**Moorhead Area Public Schools
Grades 5-6 Addition at Horizon Campus
Bid Group II
Moorhead, MN**

**Project No. 15-024
Date: May 13, 2016**

ADDENDUM NUMBER 3

SECOND LEVEL FLOOR PLAN - AREA "A"

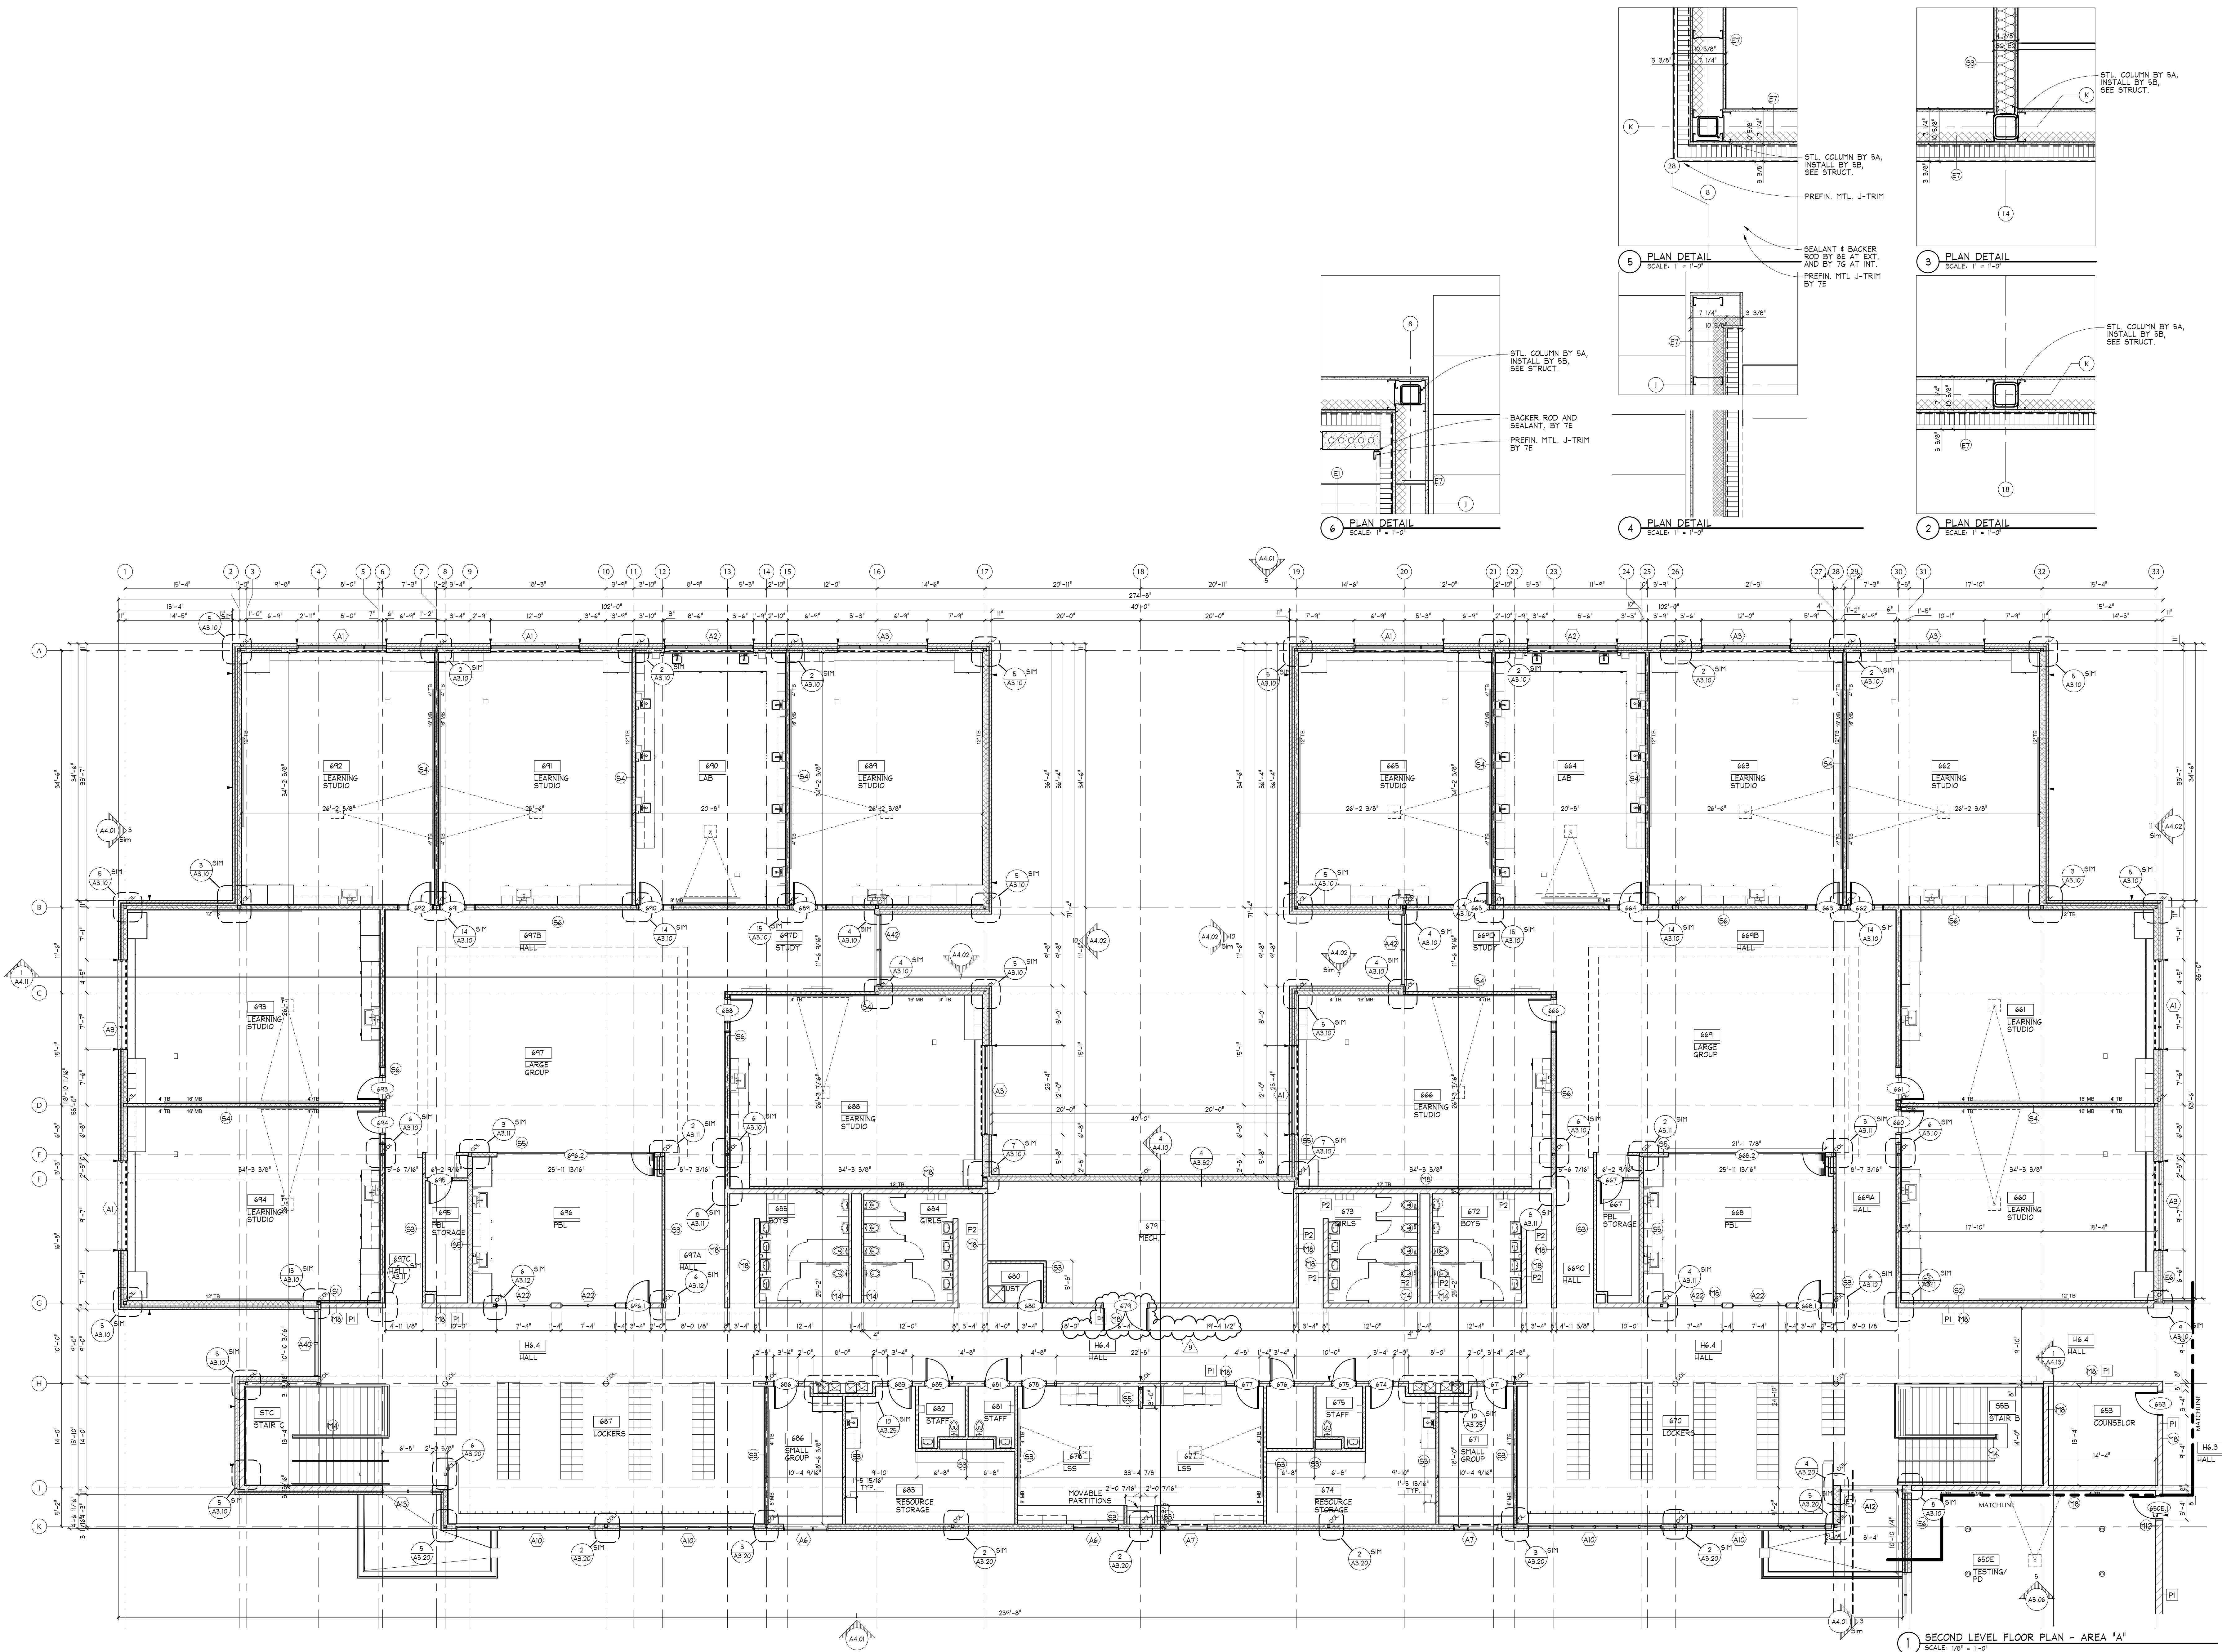
Drawing A3.20: Second Level Floor Plan - Area "A"

1. Drawing revised for mechanical room door locations.

A3.21

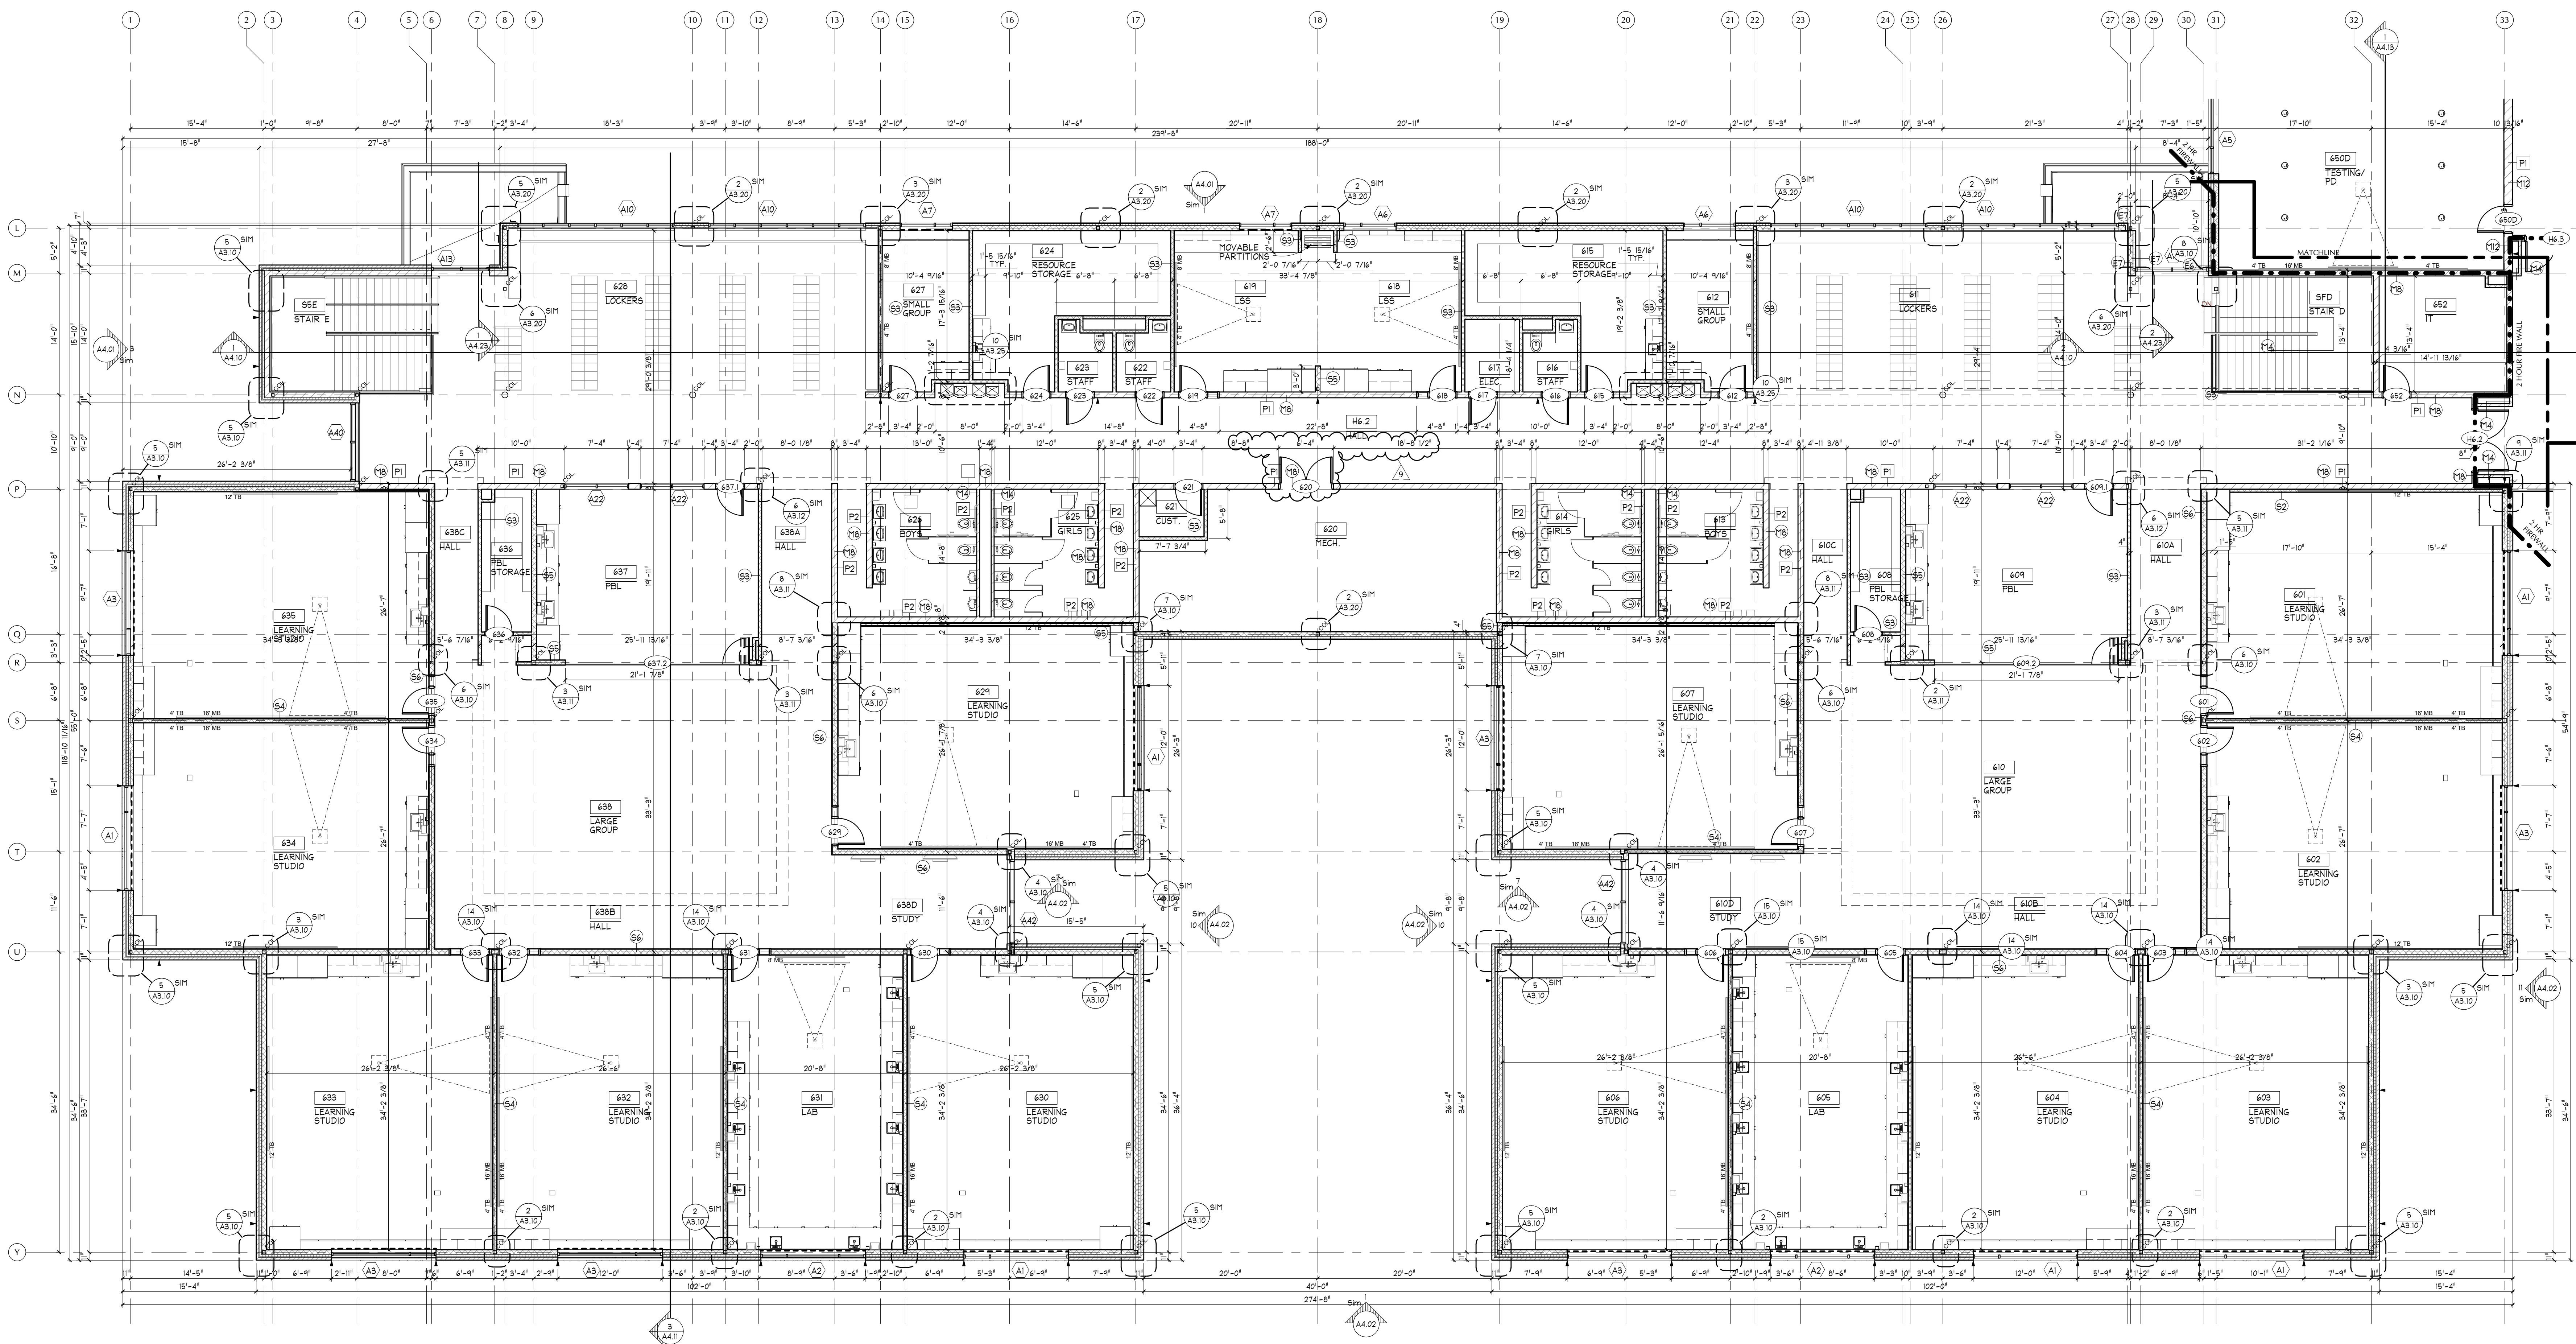
Drawing A3.21: Second Level Floor Plan - Area "B"

1. Drawing revised for mechanical room door locations.
